The Greater Cambridge Design Review Panel

Pre-application ref: 23/50499/PREPPA

Hanover Court and Princess Court, Union Road, Cambridge

Thursday 28 November 2024, In-person meeting

Site constraints and opportunities – extracted from the applicant’s DRP presentation document (November 2024)

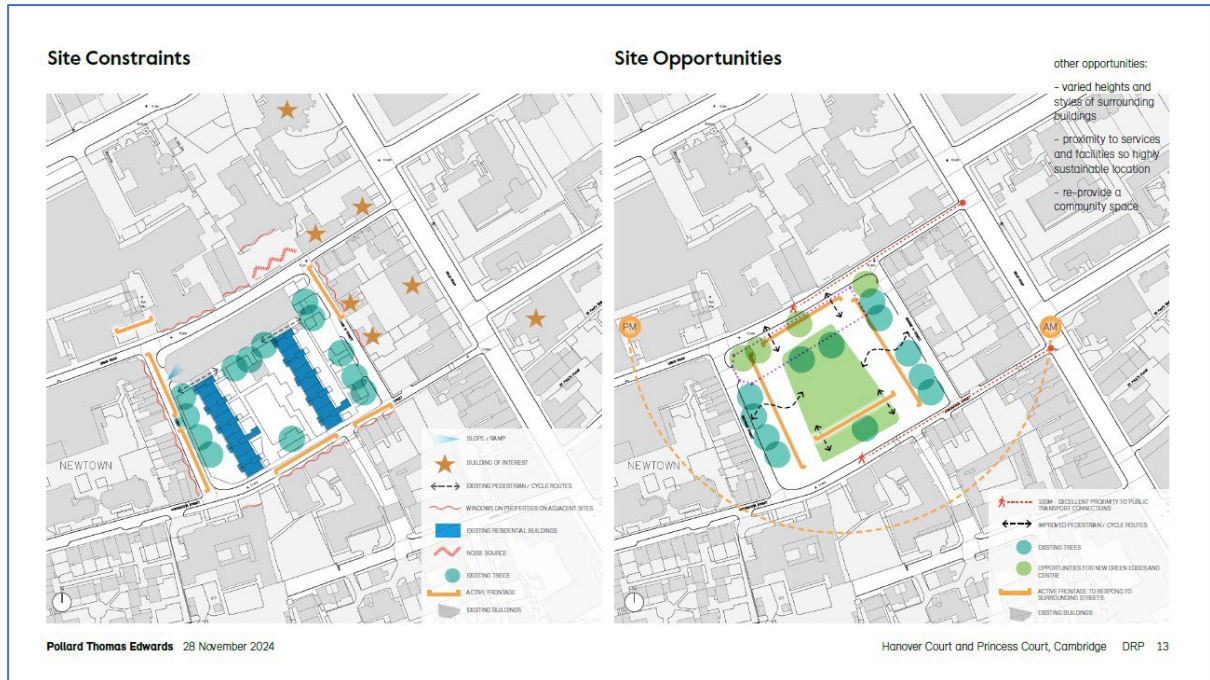
Understanding the background history to the 1960's development of the Courts and their replacement of the historic grain of streets is critical to all three levels. Even if an orthogonal arrangement is to replace the existing blocks and it does not reinstate the former grain, the Panel is of the view that the new development will need somehow to be stitched back into its surroundings, reinstating a layout with elements

that are more street-like. The design team’s ‘Site Opportunities’ diagram begins to show how this could be achieved, yet its key features have somehow been lost in the landscape plan and site layout principles.
